SUBJECT: PDC07-033 PLANNED DEVELOPMENT REZONING FROM THE A-AGRICULTURE DISTRICT AND R-1-5(PD) TO A(PD)PLANNED DEVELOPMENT ZONING DISTRICT TO ALLOW THE DEVELOPMENT OF UP TO 379 SINGLE FAMILY DETACHED RESIDENCES & 30,000 SQUARE FEET OF RETAIL, THE DEMOLITION OF TWO SINGLE FAMILY RESIDENCES AND SEVERAL ACCESSORY BUILDINGS, AND THE PRESERVATION OF ONE SINGLE-FAMILY RESIDENCE AND ONE FRUIT STAND ON A 20.52 GROSS ACRE SITE.

PC AGENDA: 5/14/08
ITEM: 4E

SUBJECT: PDC07-033, Planned Development Rezoning from the A-Agriculture District and R-1-5(PD) to A(PD)Planned Development Zoning District to allow the development of up to 379 single family detached residences & 30,000 square feet of retail, the demolition of two single family residences and several accessory buildings, and the preservation of one single-family residence and one fruit stand on a 20.52 gross acre site.

SUBJECT: PDC07-033. Planned Development Rezoning from the A-Agriculture District and R-1-5(PD) to A(PD)Planned Development Zoning District to allow the development of up to 379 single family detached residences & 30,000 square feet of retail, the demolition of two single family residences and several accessory buildings, a

**GENERAL DEVELOPMENT PLAN
EXHIBIT 'C'
CONCEPTUAL SITE PLAN**

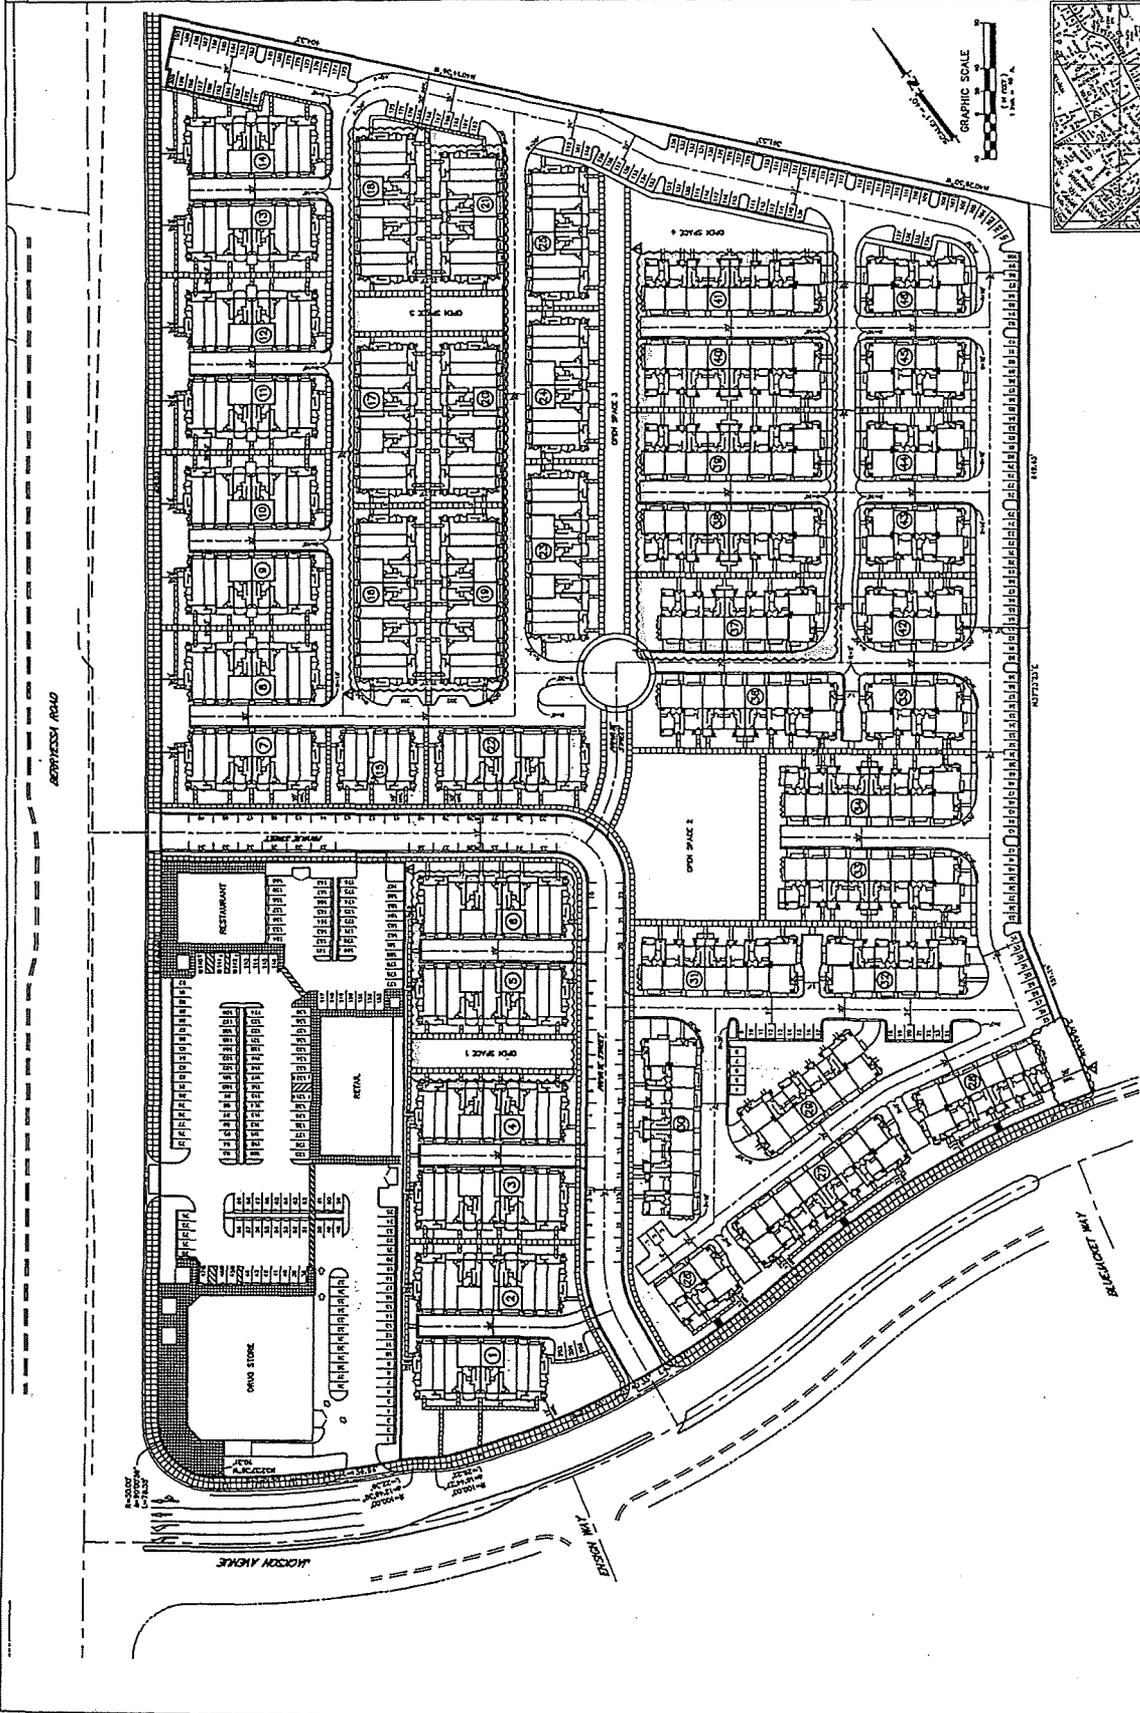
The new open space area proposed in the northeast corner of the site is located adjacent to Buildings 17-20 and labeled on the revised site plan as Open Space Area 5. This new open space area distributes recreational areas to this corner of the site that was previously void of any open space areas. In addition, the orientation of the new Open Space Area 5 is such that it links to a pedestrian walkway, which connects the open space area 5 to a larger common open space area, labeled Open Space Area 3, which is located to the south, in front of Buildings 23-25.

The previous site plan had an open space area located in the northwest corner, located between the main private road and the front yards of Building 6. The revised site plan has relocated and widened this open space area between Buildings 4 & 5, and has been labeled on the revised site plan as Open Space Area 1. This reorientation is an improvement because before the open space area was located in an area, based on its orientation that seemed as if it would be the exclusive use of residents of Building #6. By relocating the open space area between both Buildings #4 & 5, the area does not function as front yards, but rather as common area. In addition, by shifting the open space area further west as it is proposed in the redesign, more recreation area is distributed towards the western portion of the plan, where it was currently lacking.

The site plan also includes a re-orientation of the common open space which was previously proposed between Buildings #24-26 and Buildings #38-40, which functioned as an elongated paseo between these buildings. This open space area in the revised site plan has been re-oriented so that it is not straddled between buildings, but it is a long open space strip, which has Buildings #23-25 fronting on to it. This open space area is labeled area 3 on the revised site plan. In addition, in the revised site plan, a building was removed which blocked the connection between this open space area and another triangular open space area, labeled Open Space 4, to the south. The removal of this building allows for the connection of Open Space Areas 3 & 4, which results in these areas to be more functional.
